Addendum #2

RE: QUESTIONS & ANSWERS, SPECIFICATIONS, DRAWINGS AND DOCUMENTS

Project
SICKKIDS - 7A SCHEDULE - 1BEDS REFRESH
ATRIUM (SLAUGHT) WING, 170 ELIZABETH STREET, TORONTO, ON, M5G 1E8

1 AF 07 AN 01
DEMOLITION PLAN - LEVEL 7
SCALE: 1:50

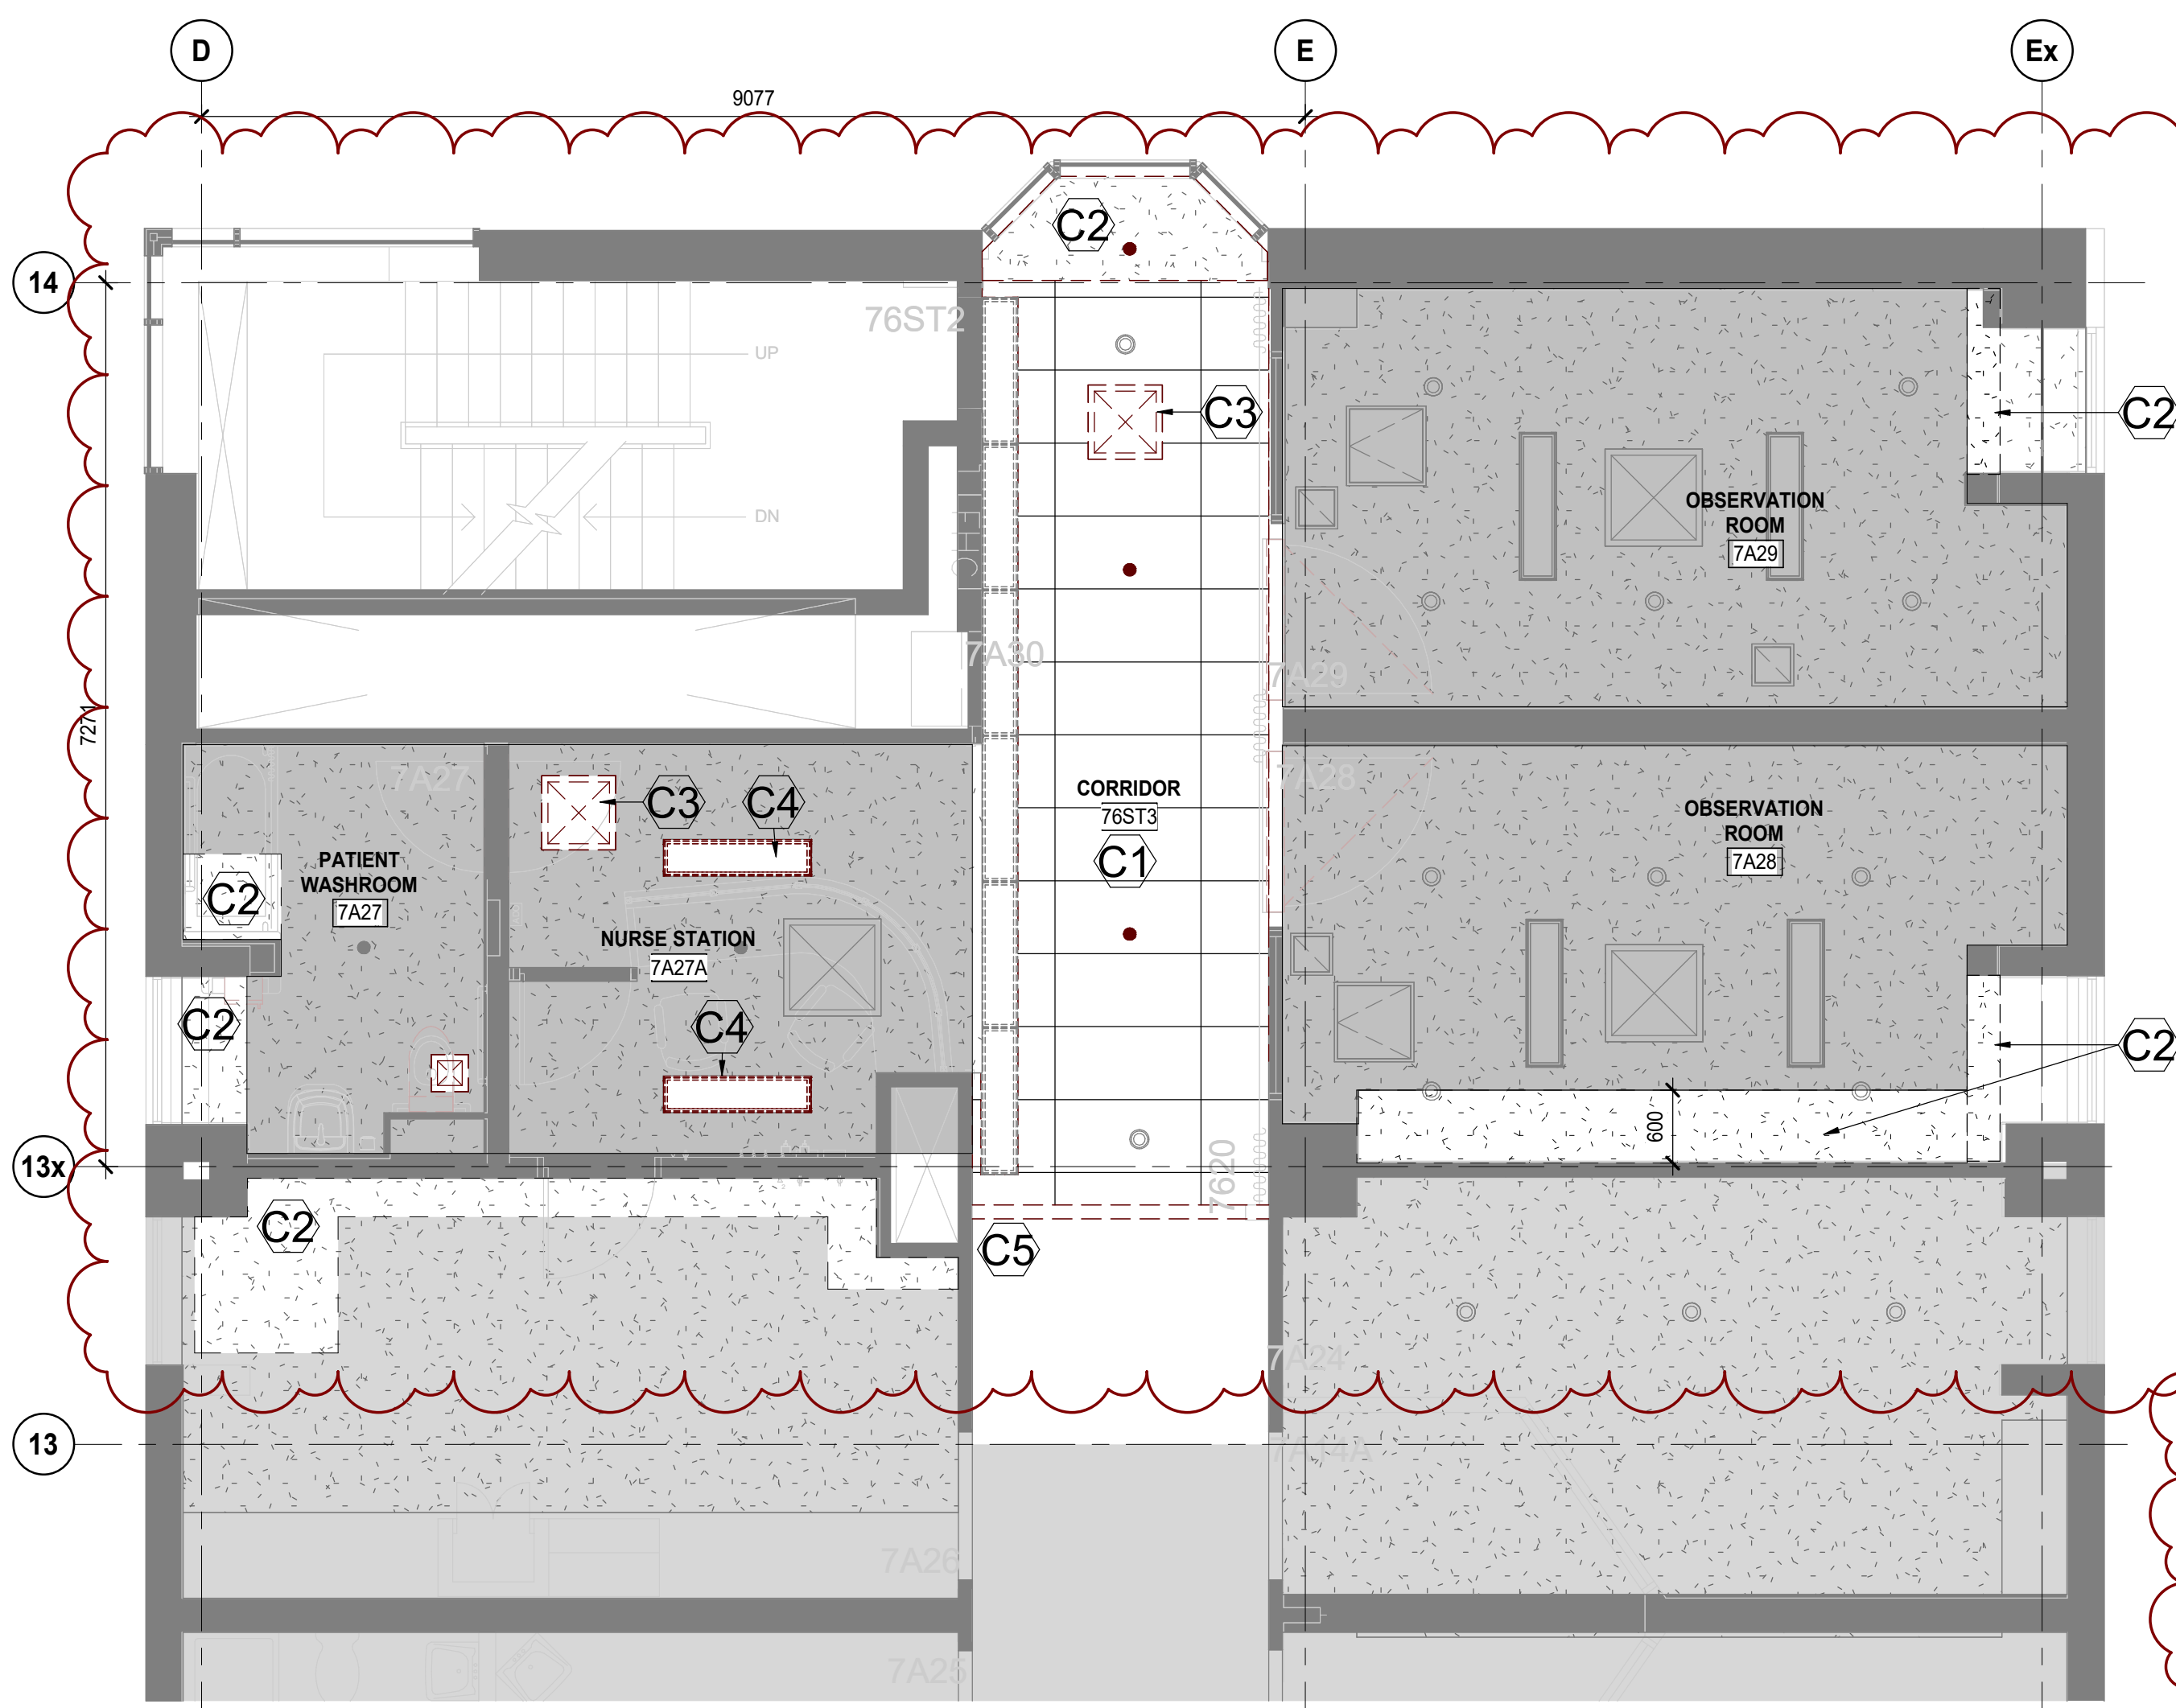
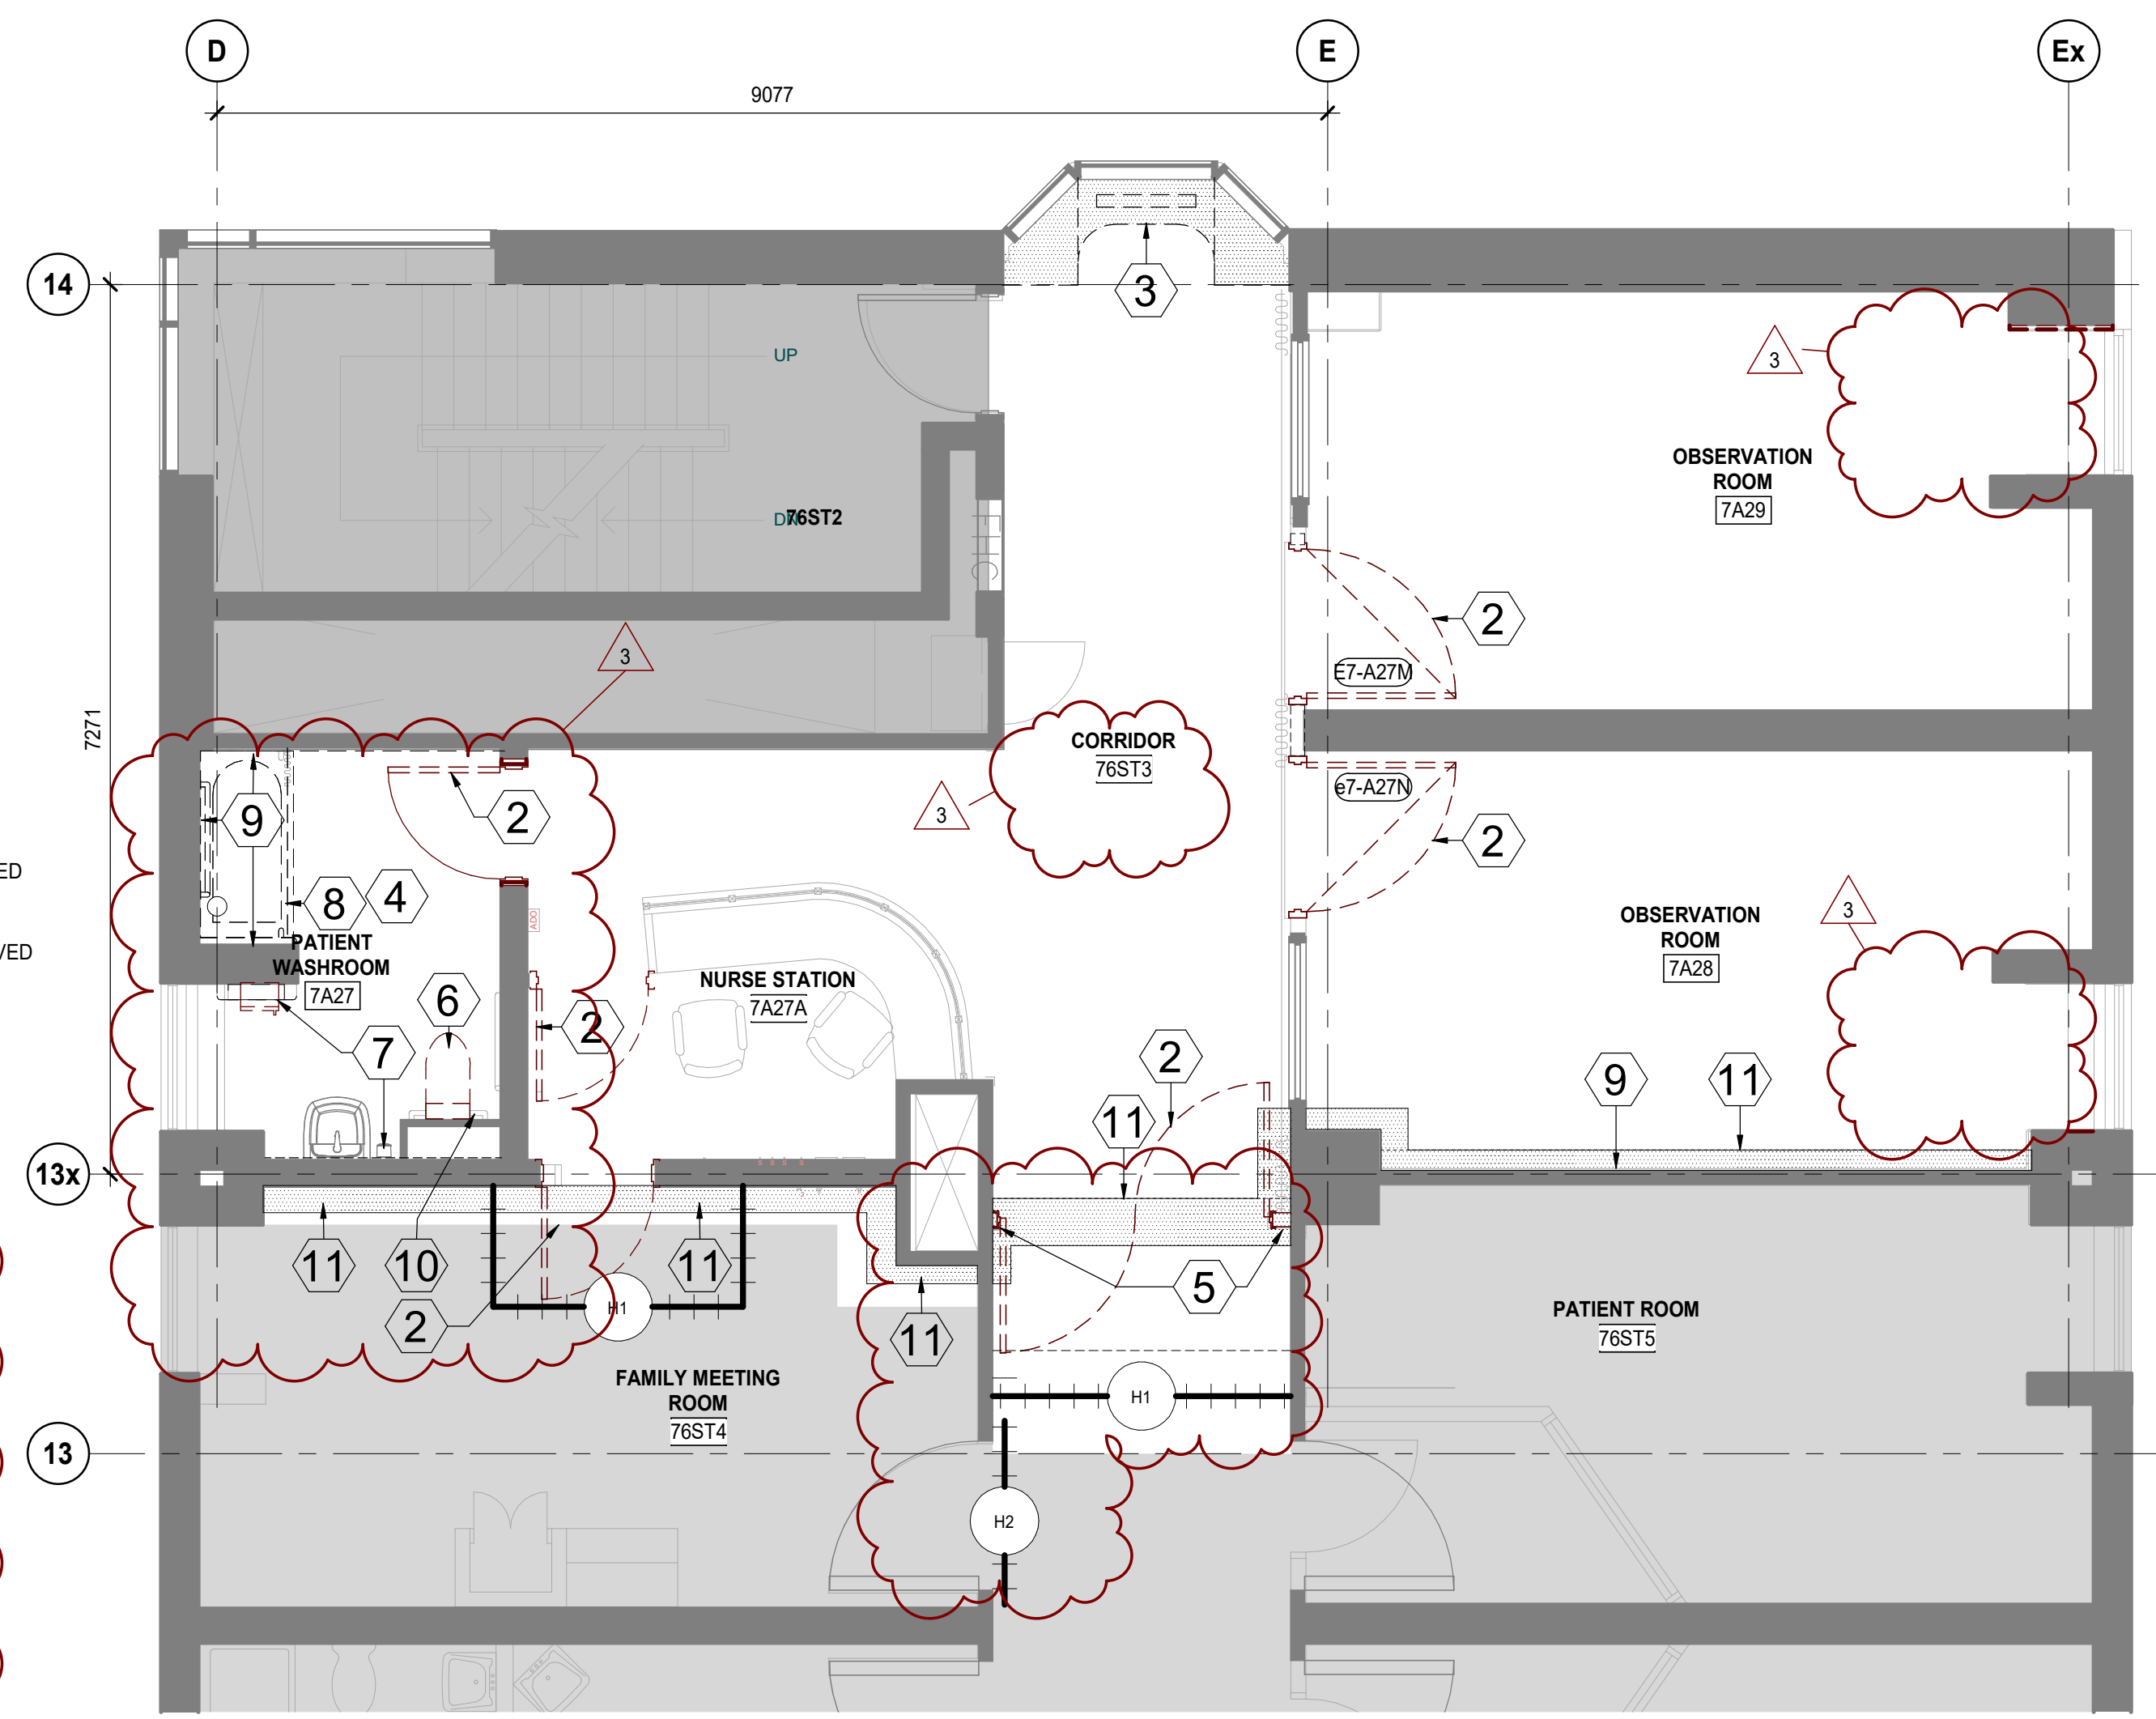
Q47- There are 2 demolition tagged notes on plan 1/AF 07 AN 01 that appear out of place. Just below room tag Corridor 76ST3 is note 4- calls for demo of flooring, yet new finish plan calls for existing floor to remain in that area. Also, note #5 demo partition is noted at the door to the

washroom. Please clarify if we are to remove any flooring in the corridor or any walls at or near the washroom door.

A47- Refer to revised Drawings issued as part of Addendum 2.
